# PCN Report

**Prepared By** : Maggie Xu, Thyristor Product Engineer  
**Date** : July 3<sup>rd</sup>, 2018  
**Products** : Thyristor Products acquired from ON Semiconductor  
**Revision** : B

This report covers manufacturing site transfer activities of Thyristor products acquired from ON Semiconductor. Site transfer includes backend assembly, final test and packaging operations.

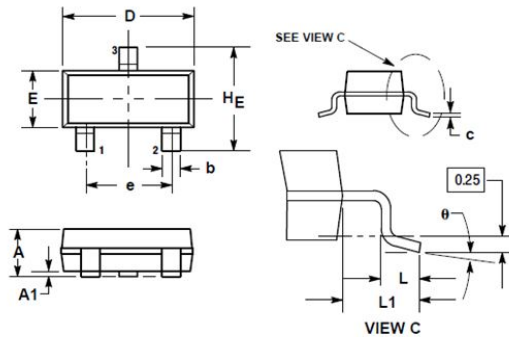
Format of Date code section of component marking is changed as follows.

PACKAGE	Date Code Format by ON Semiconductor (Old)	Date Code Format by Littelfuse (New)	Symbols
SOT23	M	YMA	Y: Year of Manufacturing M: Month of Manufacturing WW: Week of manufacturing A: Assembly location XX: Lot serial code
SOT223	AYW	YMAXX	
TO-225AA	YWW	YMAXX	
TO-251	YWW	YMAXX	
TO-252	YWW	YMAXX	
TO-220 Iso	AYWW	YMAXX	
TO-220AB	AYWW	YMAXX

##### 4.2 SOT223 Outline

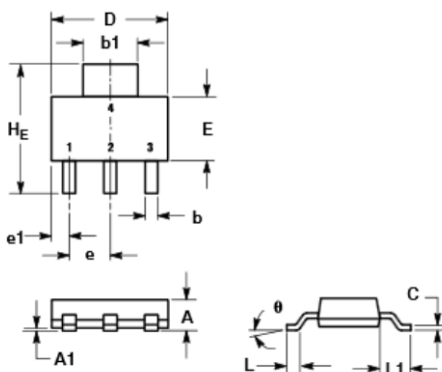
---Dimensions A, A1, c, D, e1 are different.

DIM	ON Semi Specification			Littelfuse Specification (New)		
	MILLIMETERS			MILLIMETERS		
	MIN	NOM	MAX	MIN	NOM	MAX
A	1.50	1.63	1.75	-	-	1.80
A1	0.02	0.60	0.10	0.02	0.07	0.13
b	0.60	0.75	0.89	0.66	0.75	0.84
b1	2.90	3.06	3.20	2.90	3.00	3.10
c	0.24	0.29	0.35	0.23	0.29	0.35
D	6.30	6.50	6.70	6.60	6.60	6.71
E	3.30	3.50	3.70	3.30	3.50	3.70
e	2.20	2.30	2.40	2.30 BSC		
e1	0.85	0.94	1.05	0.75	0.95	1.15
L1	1.50	1.75	2.00	1.50	1.75	2.00
He	6.70	7.00	7.30	6.80	7.00	7.20
∅	0°	-	10°	0°	-	10°
